Access Compliance Report

Public Rights-of-Way (Curb Ramps)

Intersection ID: 31490	Main Street: BULLOCK_DR	Cross Street: CLOVER_GAP_DR	Location:	E
ADA ID: 4DB590D932CA	Ramp Type: Perp	Initial Pass/Fail: Fail	Overall Compliance: No	Severity Score: 8.75

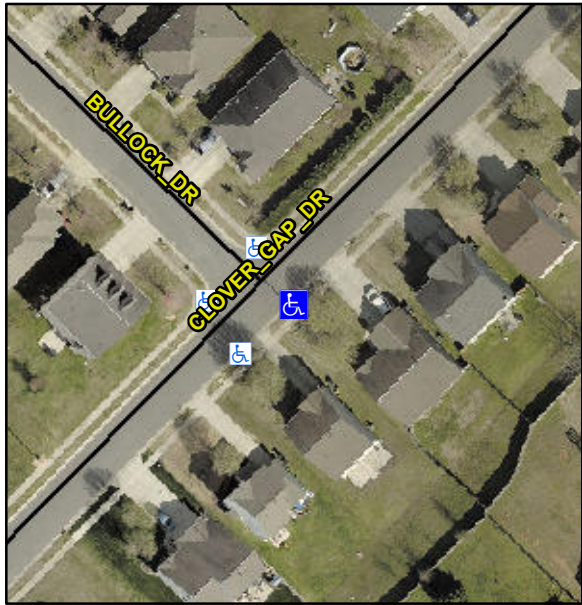
Codes/Mitigation Info/Possible Solution			Field Measurements/Component Compliance					
	Possible Solutions:		Compliance	Description	Data	Compliance	Description	Data
	Remove & Replace Entire Ramp.		N/A	Ramp Length (in)	47.0	Yes	Ramp Slope (%)	8.2
			No	Ramp Width (in)	43.0	Yes	Ramp XSlope (%)	0.9
			N/A	Flare Type LT	N/A	N/A	Flare Type RT	N/A
			N/A	Flare Slope LT (%)	N/A	N/A	Flare Slope RT (%)	N/A
			N/A	Flare Traversable LT?	N/A	N/A	Flare Traversable RT?	N/A
			N/A	Landing Length (in)	N/A	N/A	DWS Provided?	N/A
			N/A	Landing Width (in)	N/A	N/A	DWS Contrast?	N/A
			N/A	Landing Slope (%)	N/A	N/A	DWS Length (in)	N/A
			N/A	Landing X Slope (%)	N/A	N/A	DWS Full Width?	N/A
Surveyor Notes:			N/A	Landing Curb? (Y/N)	N/A	N/A	DWS Offset (in)	N/A
N/A			N/A	Shared Landing?	N/A			
PROW/ADA:			N/A	Gutter Ponding?	N/A	N/A	Gutter Slope (%)	N/A
Not Found, R304.5.1			N/A	Gutter Lip Ht (in)	N/A	N/A	Gutter X Slope (%)	N/A
